**RESOLUTION No. 12/13-35
CITY OF DAYTON, OREGON**

Title: A Resolution Adopting Public Works Design Standards Update No. 5

SUBJECT: Public Works Design Standards Update No. 5

LAST REVISION DATE: NOV 2011	COPYRIGHT 1995 WESTECH ENGINEERING, INC.
TYPE 'A' CURB AND GUTTER AND WEEP HOLE (NTS)	
DAYTON, OR	DETAIL NO. 210

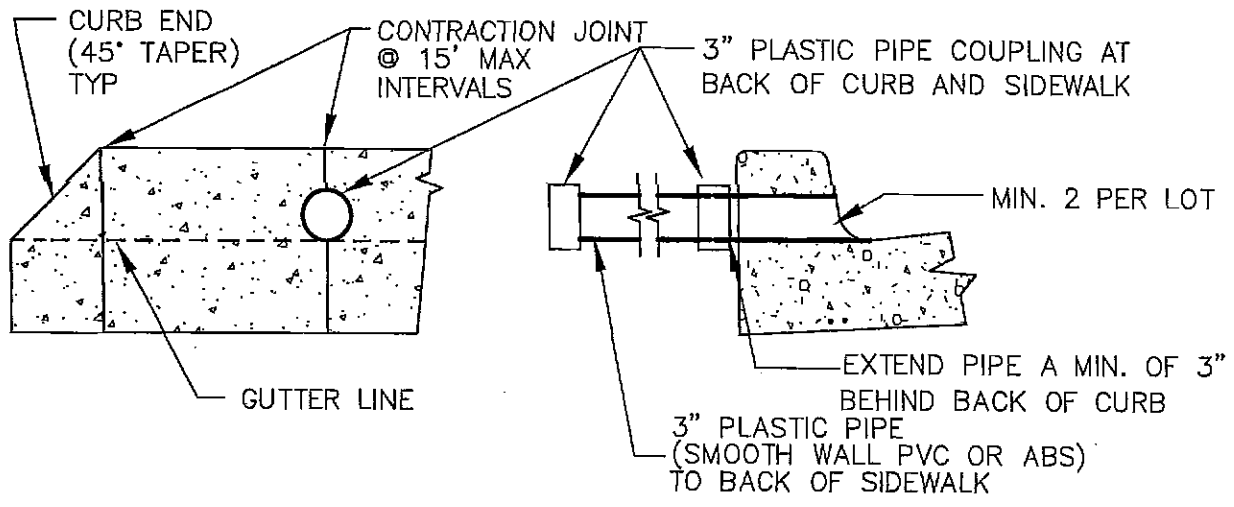
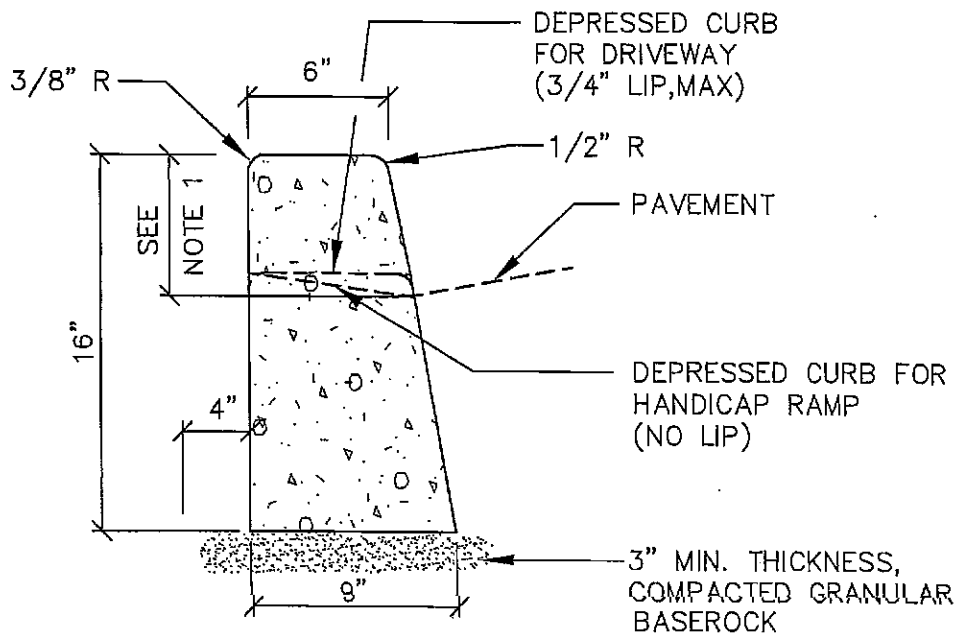
41. Detail 210 & 211: The callouts on the curb details were modified to correct a typographic error on the tooled radius on the back edge of the curb (3/8" rather than 1/8"). The revised detail (see attached) is dated 11/11.

LAST REVISION DATE: JUNE 2012	COPYRIGHT 1996 WESTECH ENGINEERING, INC.
CURBLINE SIDEWALKS AND DRIVEWAY APRONS	
(NTS)	
DAYTON, OR	DETAIL NO. 212

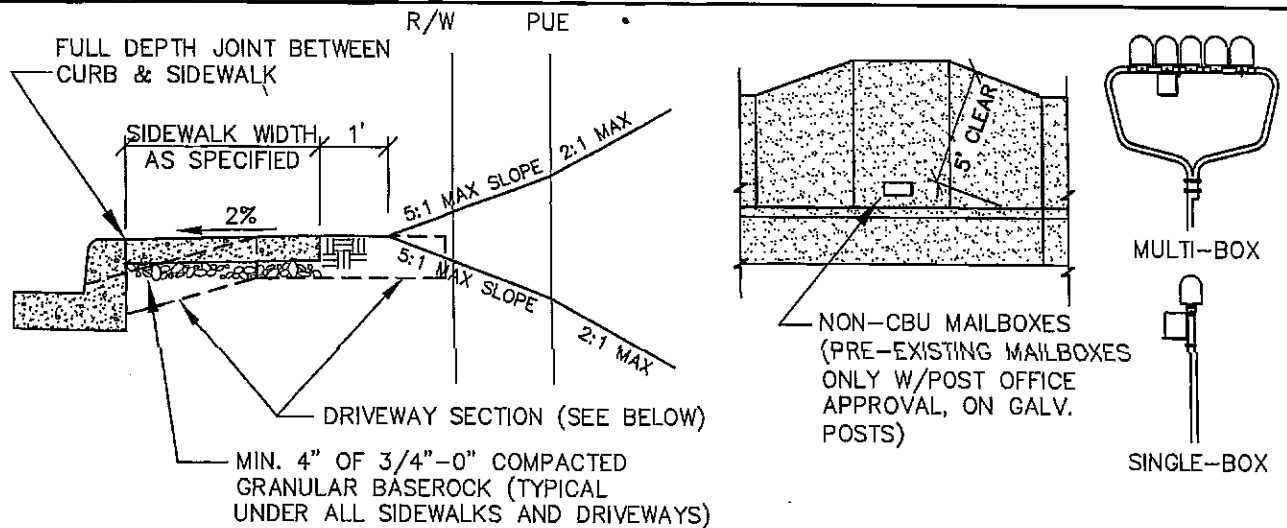
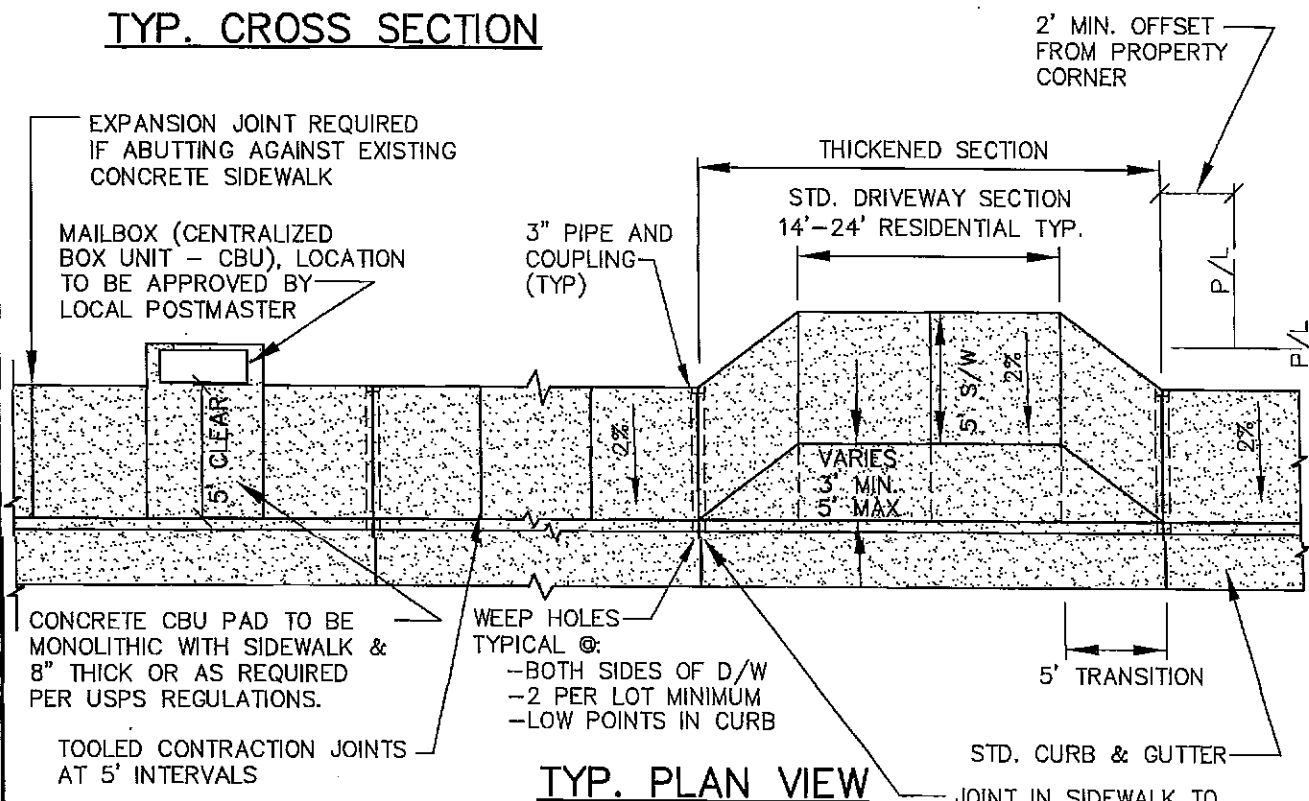
42. Detail 212, 212a & 213: The sidewalk details were modified to bring the notes on the various details into agreement with each other, clarify the need for sidewalk easements at corners where applicable, and clarify the offset of driveways from property corners in order to comply with ORS 92.044(7), which requires utility improvements (including drain pipes) to be offset from property pins. Details 212 & 213 were revised to conform with state law which requires local design standards to reference current State ADA standards for clustered mail boxes (which are in the Oregon Structural Specialty Code) for those units located within public rights-of-way. The revised detail 212a (see attached) is dated 1/12, and the revised details 212 and 213 are dated 6/12.

LAST REVISION DATE: APR 2013	COPYRIGHT 1995 VESTECH ENGINEERING, INC.
48" SQUARE TREE WELL COVER PANELS (NTS)	
DAYTON, OR	DETAIL NO. 213A

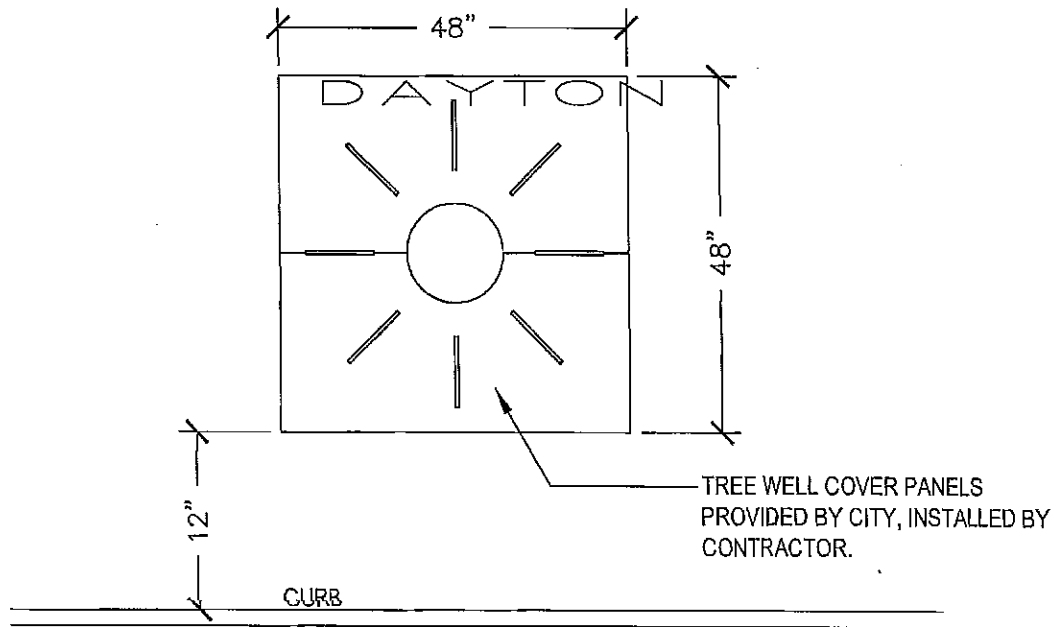
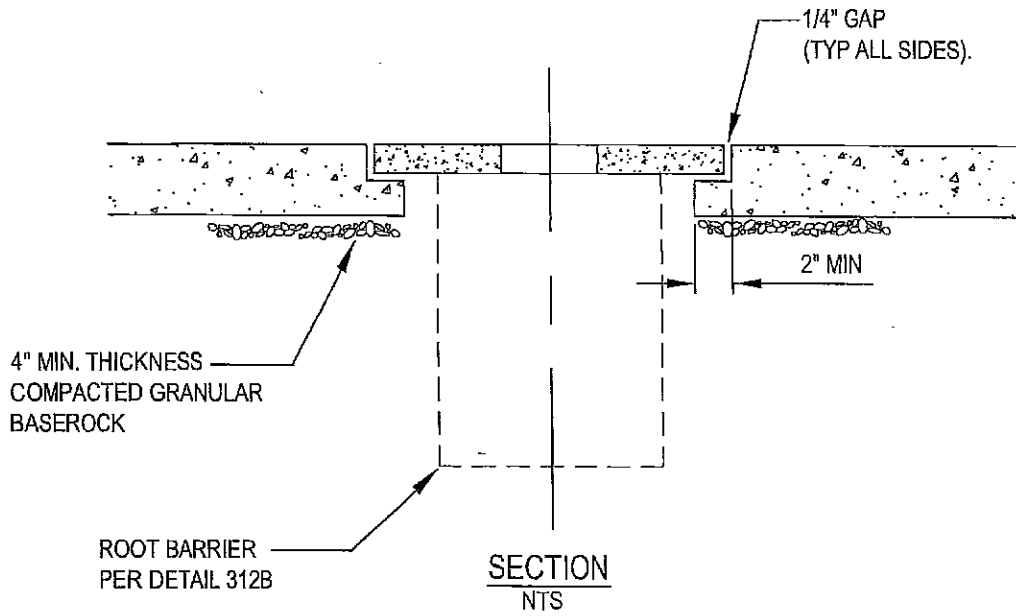
43. Detail 213A, 213B & 213C: Details were added to reflect the City's standard configuration for tree well covers (for street trees within the CBO zone), as well as the configuration of tree wells for street trees within the public right-of-way. The new detail 213A (see attached) is dated 4/13, and the revised details 213B and 213C are dated 11/12.

HANDICAP RAMPS

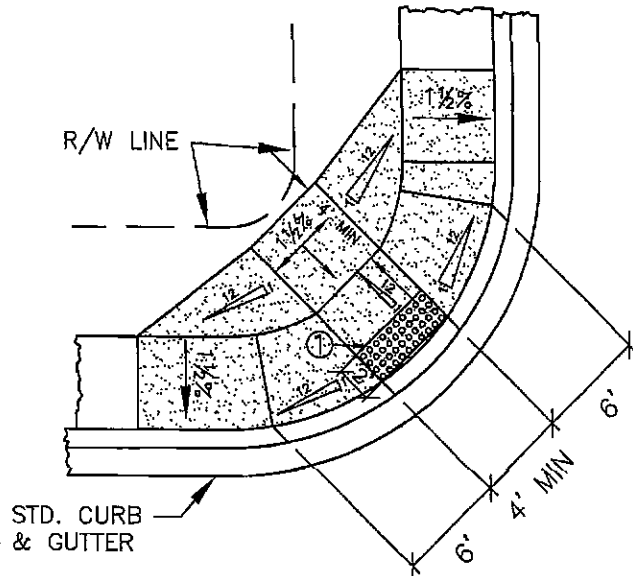
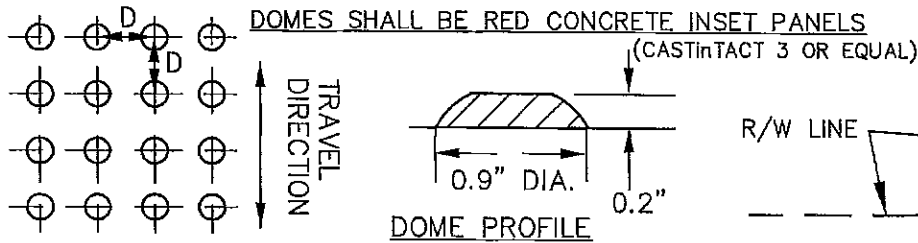
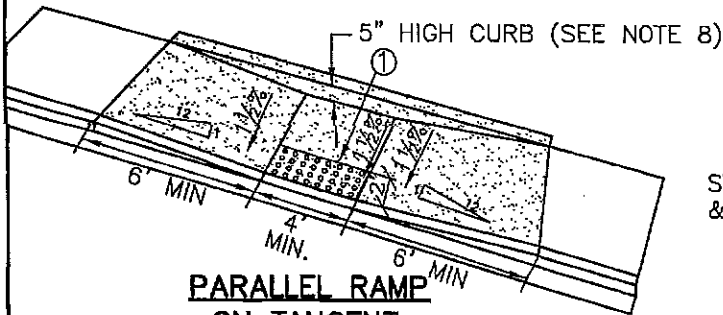
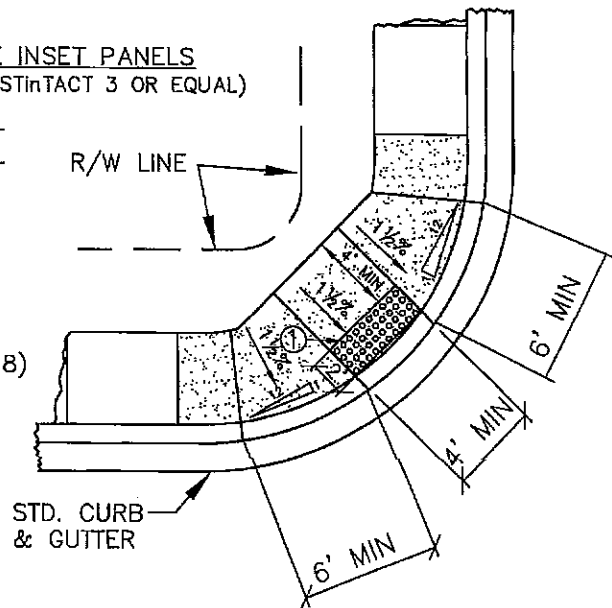
44. Detail 214: The notes on the handicap ramp detail were modified to clarify the type of truncated domes specified under City standards. The revised detail (see attached) is dated 11/11.

LAST REVISION DATE: NOV 2011	COPYRIGHT 1986 WESTECH ENGINEERING, INC.
COMMERCIAL DRIVEWAY APPROACH	
(NTS)	
DAYTON, OR	DETAIL NO. 216

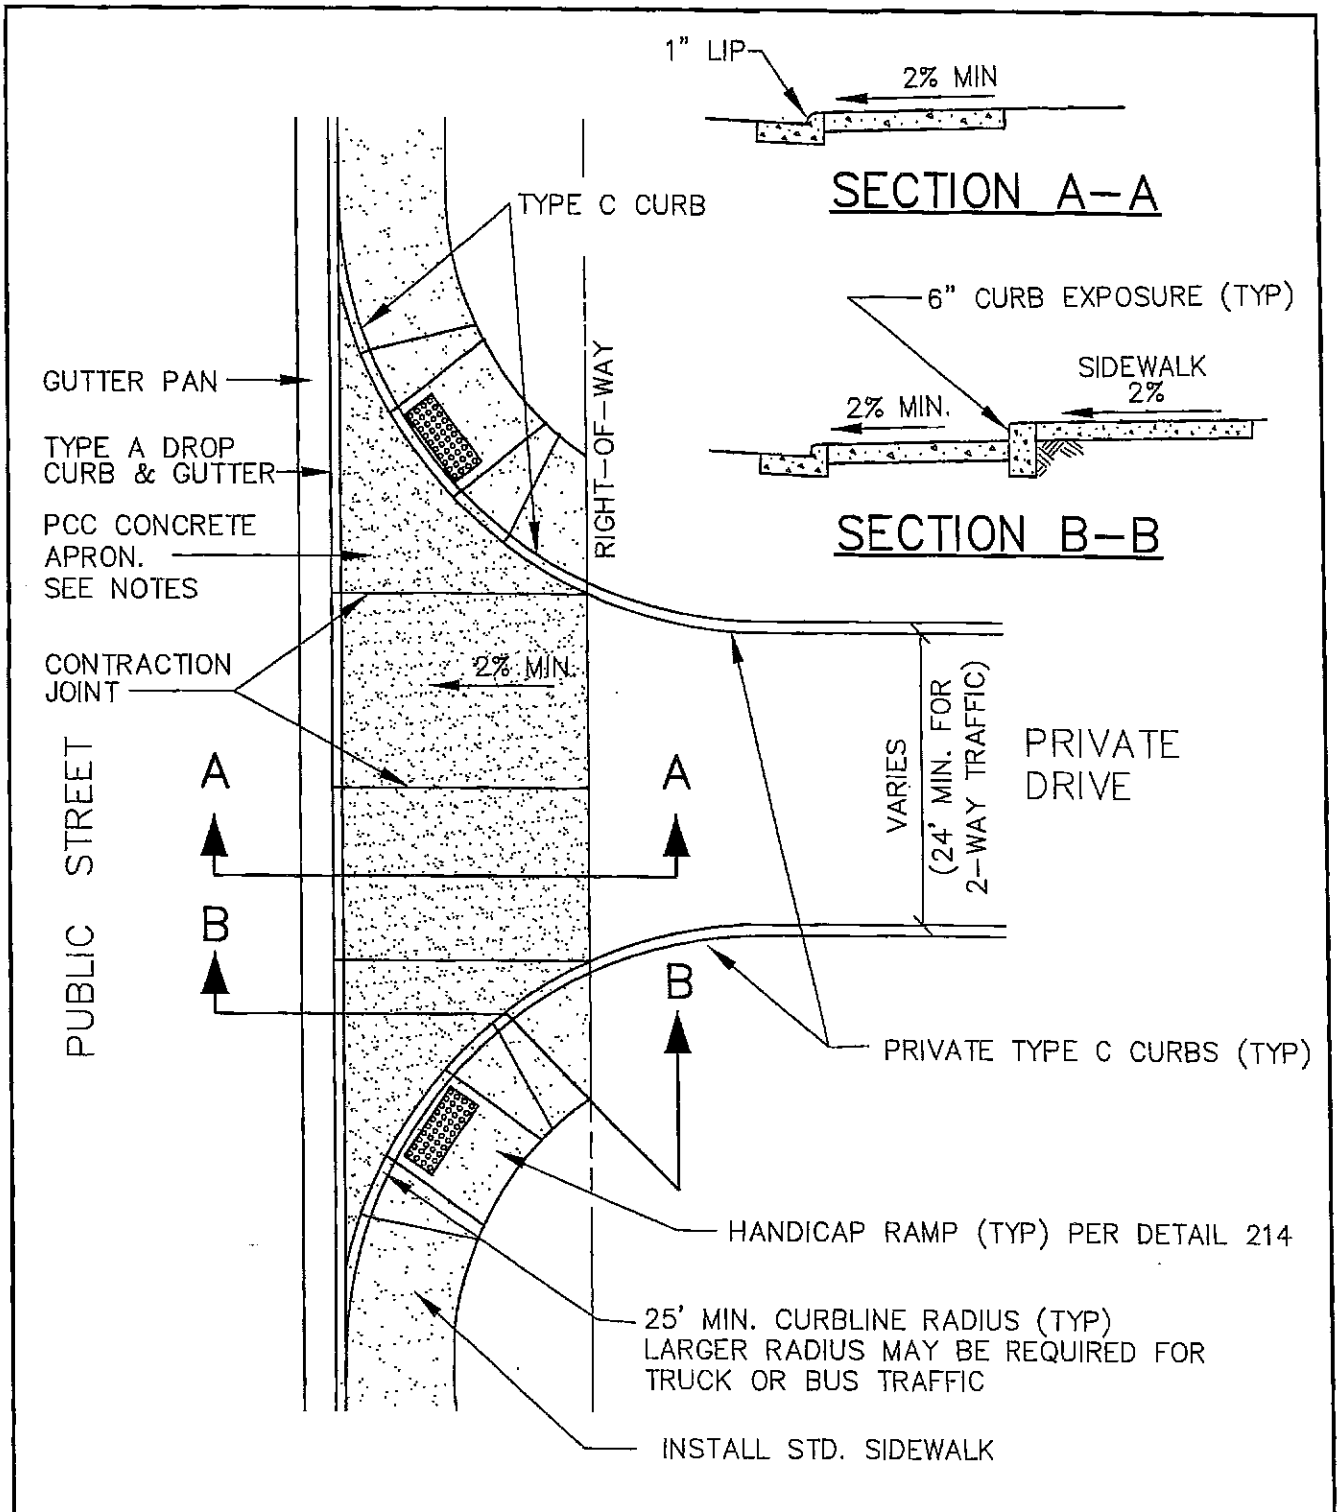
45. Detail 216: The commercial driveway detail was modified to clarify the driveway width and reinforcing. The revised detail (see attached) is dated 11/11.

LAST REVISION DATE: SEPT 2012	COPYRIGHT 1998 WESTECH ENGINEERING, INC.
HAMMERHEAD TURNAROUND (PRIVATE DRIVES ONLY)	
(NTS)	
DAYTON, OR	DETAIL NO. 220

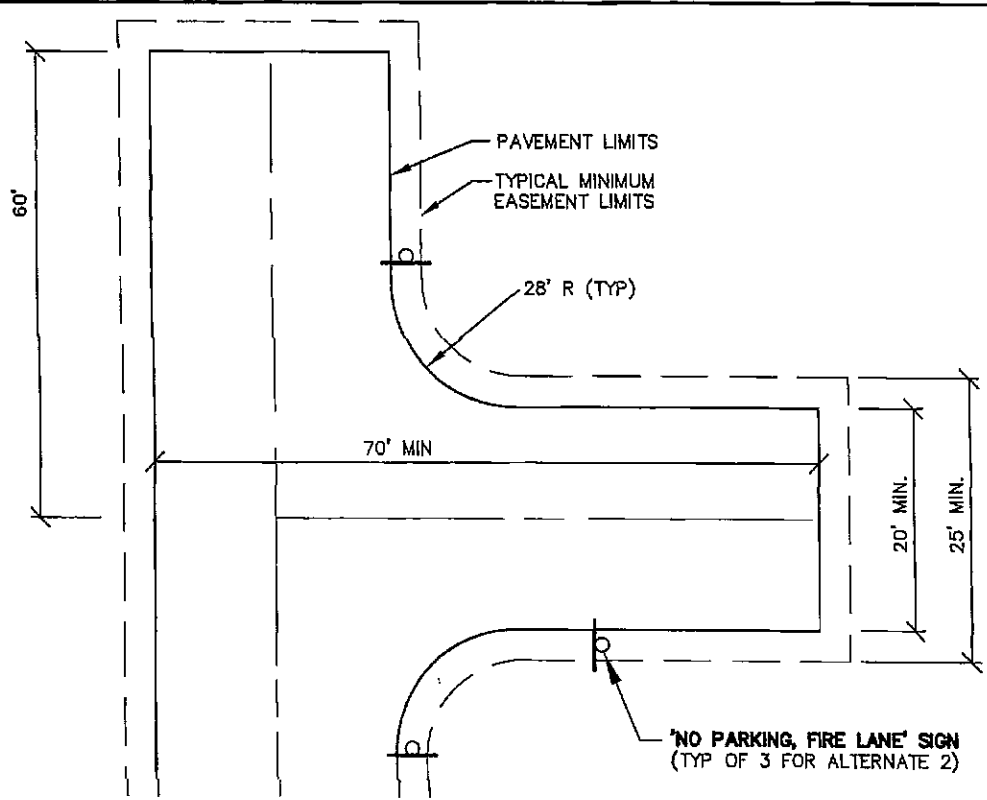
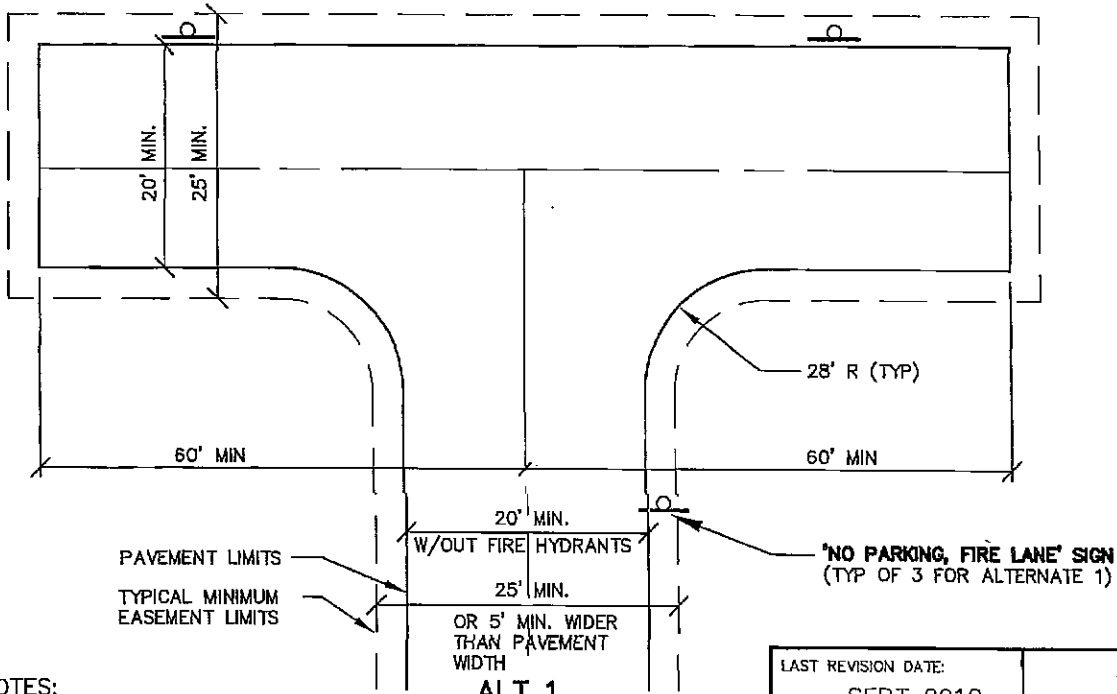
46. Detail 220: The hammerhead turnaround detail was modified to clarify requirements for the no parking/fire lane signs required by the Oregon Fire Code. The revised detail (see attached) is dated 9/12.

LAST REVISION DATE: JUNE 2011	
TYPICAL STREET LAMP POST	
(NTS)	
DAYTON, OR	DETAIL NO. 230

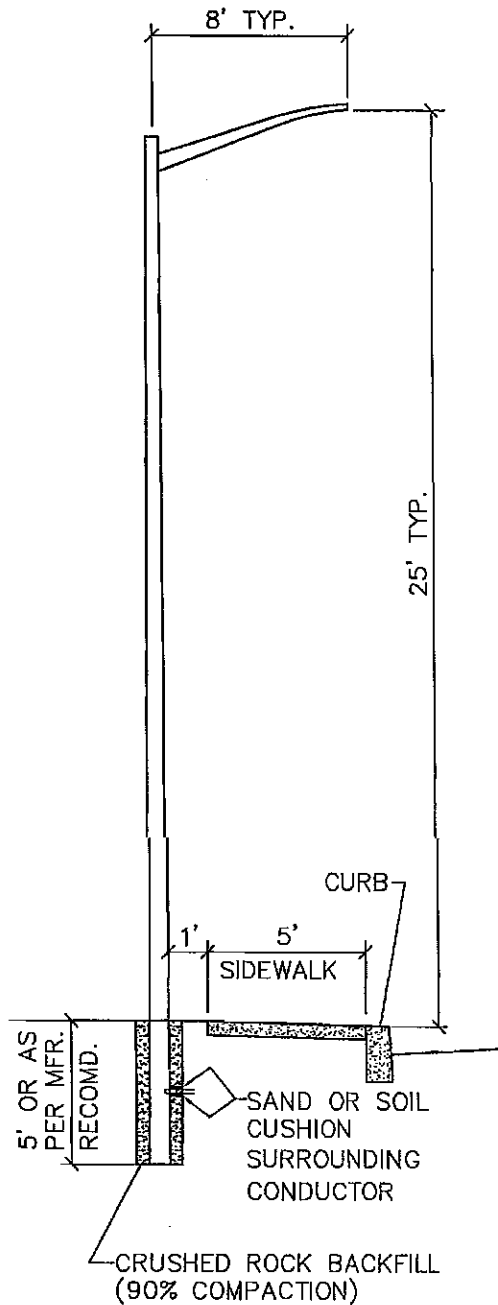
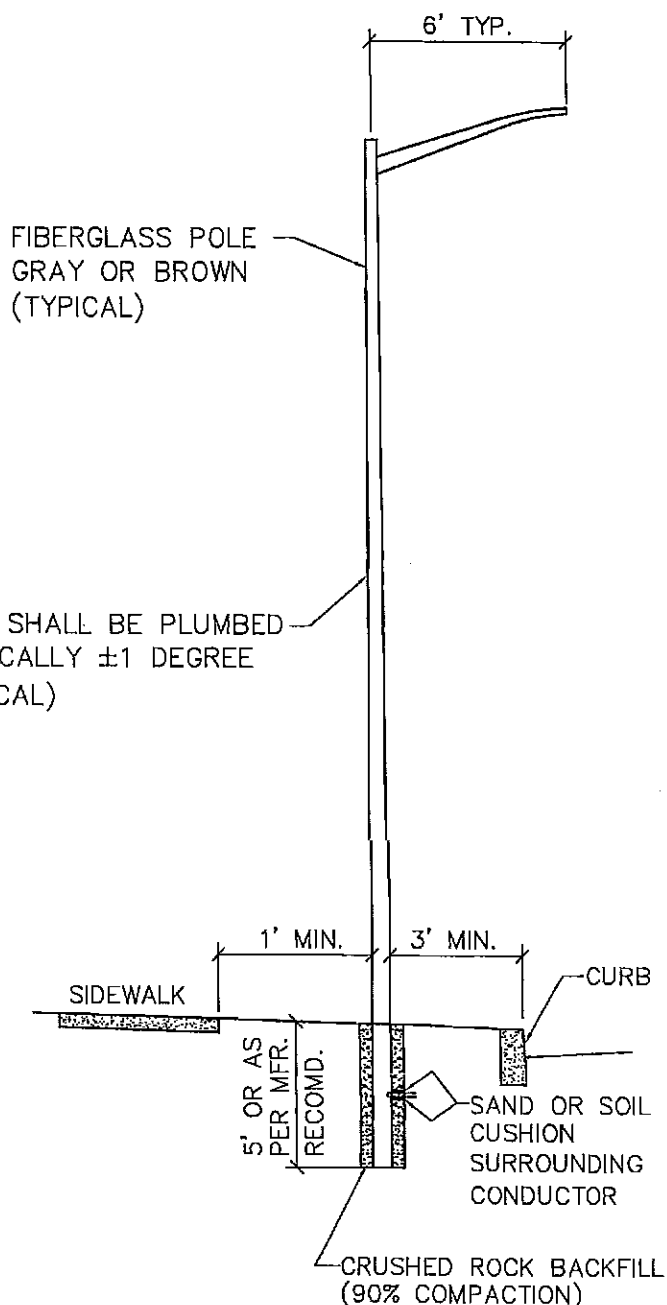
47. Detail 230: The street light detail was modified to add the standard fixture specified by PWDS 2.10. The revised detail (see attached) is dated 6/11.
